Item Name: Basket Hinge Kit

DESIGN UP	DRAWN BY UP	DART AEROSPACE LTD HAWKESBURY, ONTARIO, CANADA	
CHECKED #	APPROVED #	DRAWING NO. DSI 9053	REV. B SHEET 1 OF 2
DATE 01.04.16		TITLE BASKET HINGE CHANGE SCALE NTS	
A	96.11.06	NEW ISSUE	
B	01.04.16	REDRAWN

DART SERVICE INSTRUCTION

TO AMEND INSTALLATION DRAWING D205-541 REV. D
(REF. CANADIAN STC: SH96-120, FAA STC: SR00696NY)
AND INSTALLATION DRAWING D350-607 REV. E
(REF. CANADIAN STC: SH94-14, FAA STC: SR00213NY)

DESIGN	AP	DRAWN BY	AP	DART AEROSPACE LTD HAMMERSBURY, ONTARIO, CANADA
CHECKED	AP	APPROVED	AP	REV. B
DATE	01.04.16	DRAWING NO.	DSI 9053	SHEET 2 OF 2
TITLE	BASKET HINGE CHANGE	SCALE	NTS

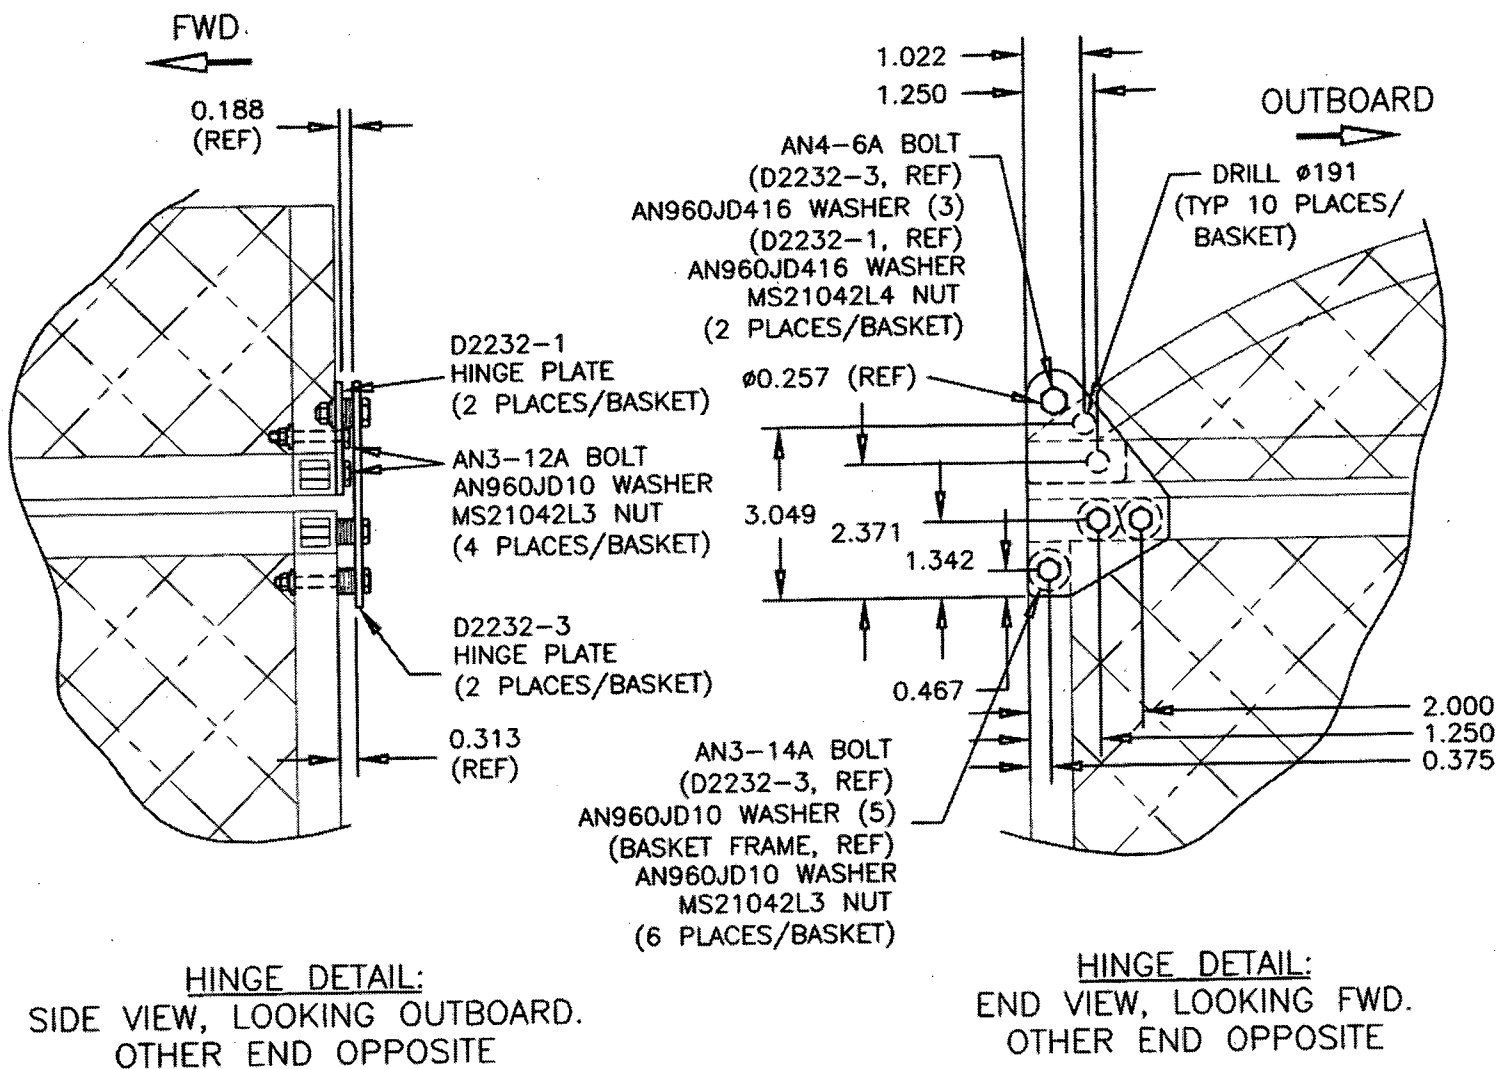
IF THE D2569 HINGE IS BEING REPLACED, THE PARTS LIST OF D205-541 REV. D (D205-541-011 CHG 003) / D350-607 REV. E (D350-607-041/-042 CHG 004) SHOULD BE AMENDED AS FOLLOWS:

REPLACE:

Qty	Part Number	Description
1	D2569	HINGE
36	AD64ABSLF	RIVET

WITH:

Qty	Part Number	Description
X	DSI 9053-011	HINGE CHANGE KIT
2	D2232-1	HINGE PLATE
2	D2232-3	HINGE PLATE
4	AN3-12A	BOLT
6	AN3-14A	BOLT
2	AN4-6A	BOLT
40	AN960JD10	WASHER*
8	AN960JD416	WASHER*
10	MS21042L3	NUT (OR MS21042-3)
2	MS21042L4	NUT (OR MS21042-4)

* NOTE: IT IS ALSO ACCEPTABLE TO REPLACE THE WASHERS THAT ARE USED AS SPACERS WITH A SINGLE ALUMINUM SPACER OF APPROPRIATE LENGTH (SEE PAGE 2).

REPLACE D2569 HINGE AS FOLLOWS:

- 1) REMOVE EXISTING HINGE BY DRILLING OUT AD64ABSLF RIVETS. PLUG HOLES WITH RIVETS IF DESIRED.
- 2) DRILL HOLES IN D2232-1/-3 HINGE PLATES AS SHOWN ON PAGE 2.
- 3) LOCATE D2232-1 HINGE PLATE ON D2512 BASKET LID ASSEMBLY. REMOVE MESH AS REQUIRED SO THAT D2232-1 HINGE PLATE SITS FLUSH ON D2512 BASKET LID ASSEMBLY. TRANSFER DRILL Ø0.191 HOLES. INSTALL D2232-1 HINGE PLATE WITH HARDWARE AS SHOWN ON PAGE 2. REPEAT AT OTHER END OF BASKET.
- 4) LOCATE POSITION OF D2232-3 HINGE PLATE FROM D2232-1 HINGE PLATE BY ENSURING Ø0.257 HOLE IS ALIGNED. REMOVE MESH AS REQUIRED TO ENSURE THAT D2232-3 HINGE PLATE AND ATTACHMENT HARDWARE SITS FLUSH AGAINST D2206/D2221 BASKET BASE ASSEMBLY. TRANSFER DRILL Ø0.191 HOLES. INSTALL D2232-3 HINGE PLATE WITH HARDWARE AS SHOWN ON PAGE 2. REPEAT AT OTHER END OF BASKET.
- 5) TOUCH UP PAINT AS REQUIRED.
